Access Compliance Report Public Rights-of-Way (Curb Ramps)

Main Street: MONTECITO_RD		Cross Street: WOODSTOCK_RD		Location:	SW
ADA ID: RPRK211209125627	Ramp Type: Type 4 - Parallel	Initial Pass/Fail: Fail	Overall Compliance: No	Severity Score:	15
Codes/Mitigation Info/Possible Solution			Field Measurements/Component Compliance

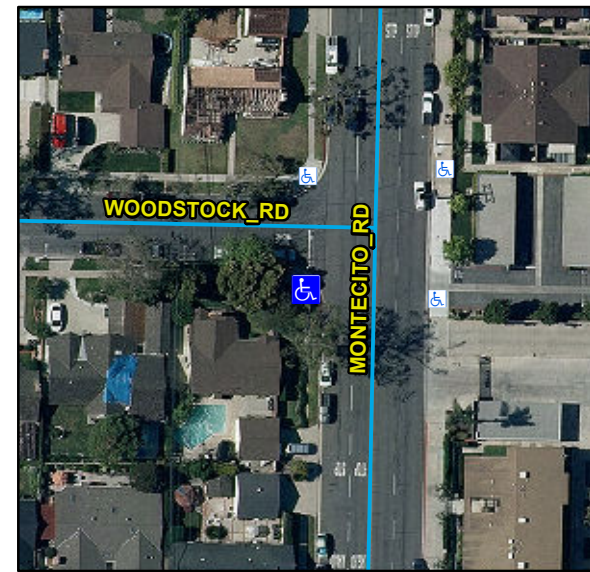
Compliance	Description	Data	Compliance	Description	Data
N/A	Ramp Length LT (in)	120	N/A	Ramp Length RT (in)	109
Yes	Ramp Width LT (in)	117	Yes	Ramp Width RT (in)	117
Yes	Ramp Run Slope LT (%)	5.8	Yes	Ramp Run Slope RT (%)	1.8
No	Ramp Cross Slope LT (%)	3.4	No	Ramp Cross Slope RT (%)	6.7
N/A	Landing Present	N/A	N/A	DWS Provided	N/A
N/A	Landing Length (in)	N/A	N/A	DWS Contrast	N/A
N/A	Landing Width (in)	N/A	N/A	DWS Length (in)	N/A
N/A	Landing Run Slope (%)	N/A	N/A	DWS Full Width	N/A
N/A	Landing Cross Slope (%)	N/A		DWS Offset Type	N/A
N/A	Landing Movement Obstructed?	N/A	N/A	DWS Offset Left (in)	N/A
	Landing Movement Type	N/A	N/A	DWS Offset Right (in)	N/A
N/A	Landing Shared	N/A			
N/A	Clear Space	Yes			
N/A	Clear Space To Crosswalk (in)	N/A			
N/A	Marked Crosswalk 1	No	N/A	Marked Crosswalk 2	No
	Crossing 1 Direction	E		Crossing 2 Direction	N
	Marked Crosswalk 1 Width (in)	N/A		Marked Crosswalk 2 Width (in)	N/A

Remove & Replace Curb Ramp With Two New Directional Ramps or Equivalent.

R204.3, R304.5.3, STD 1115
